Piper Aircraft Corporation  
2926 Piper Drive  
Vero Beach, Florida, U.S.A. 32960

# SERVICE *No. 974* BULLETIN

Aileron Hinge Inspection and Replacement

PA-31, 31-300, 31-325 Navajo  
PA-31-350 Navajo Chieftain  
PA-31-350 T1020  
PA-31P-350 Mojave  
PA-31T3 T1040

SKETCH A

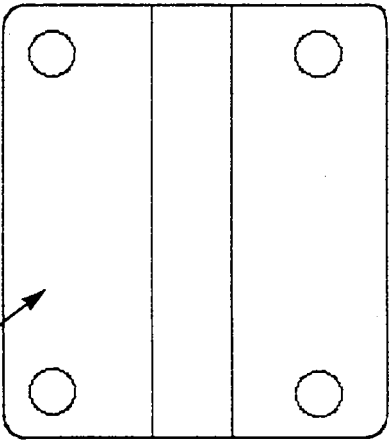
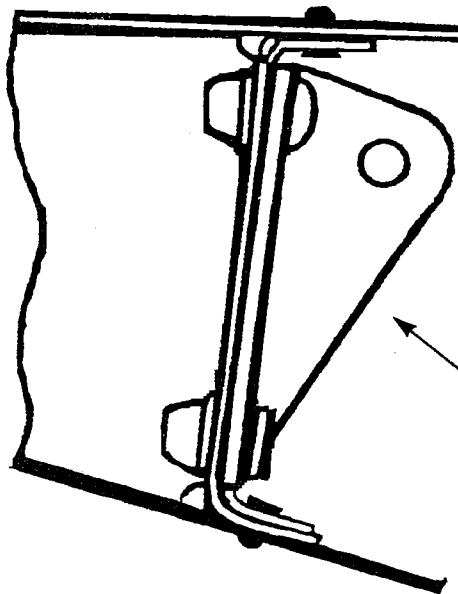
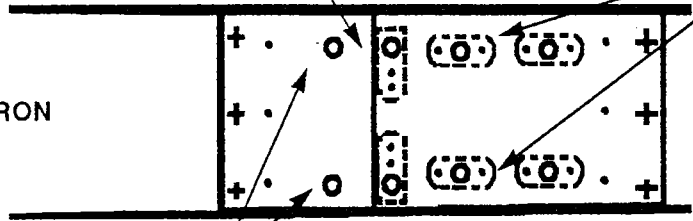
INSPECT:  
CRACKS WILL  
APPEAR ALONG  
SPAR FLANGE  
AND AT ATTACH  
HOLES.

ADD HOLES & NUTPLATES

EXISTING HINGE HOLES

INSPECT:  
CRACKS WILL  
APPEAR ALONG  
SPAR FLANGE  
AND AT ATTACH  
HOLES.

INSTALL NEW HINGE  
P/N'S 74461-02 (LEFT)  
AND 74461-03 (RIGHT)
